Notice to all Bidders

RE: CLARIFICATION NO. 2

Contract Title: Design, supply, installation and commissioning of the 400/220 kV Kimuka Substation and Associated Transmission Lines

Contract No.: KE-KETRACO-416094-CW-RFB

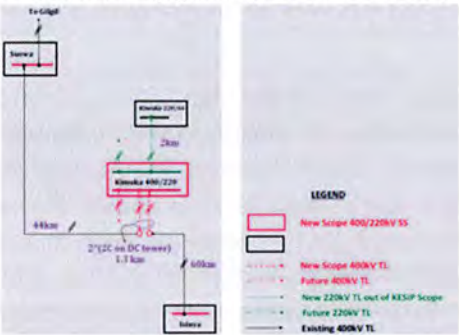
90	/	According to the tender drawings, the circuit breaker failure protection for each string should be considered to be implemented within the busbar differential protection and the protection devices of related lines or main transformer intervals. However, based on engineering experience, circuit breaker failure protection is generally configured for 3/2 connections. Please ask the owner to confirm whether	Follow the requirements as indicated in Employer's Requirements- B – Specifications clause 8.2.1.2 item i and relevant protection single line diagrams.

Item	Reference	Clarification	Responses
		it is necessary to provide a circuit breaker failure protection device and related screen cabinets.	
91	/	According to the tender drawings, the short lead protection function will be realized in the line protection. Please ask the owner to confirm whether an independent short lead protection device and screen cabinet need to be configured.	We do not understand what short lead protection is. We have not referenced such a function in our bid documents.
92	BoQ Schedule 1A-SS 7.1	The BOQ shows that the 220kV line protection is for two optical difference protections, but the drawing shows it as distance + optical difference. Please have the owner confirm the configuration plan.	Refer to Clarification no 1 item 137
93	BoQ Schedule 1A-SS 6.1.1.1	Whether all the "Mandatory Spare" related to protection in BOQ only provides devices or screen cabinets.	The price schedule line item clearly indicates what the spare requirement is.
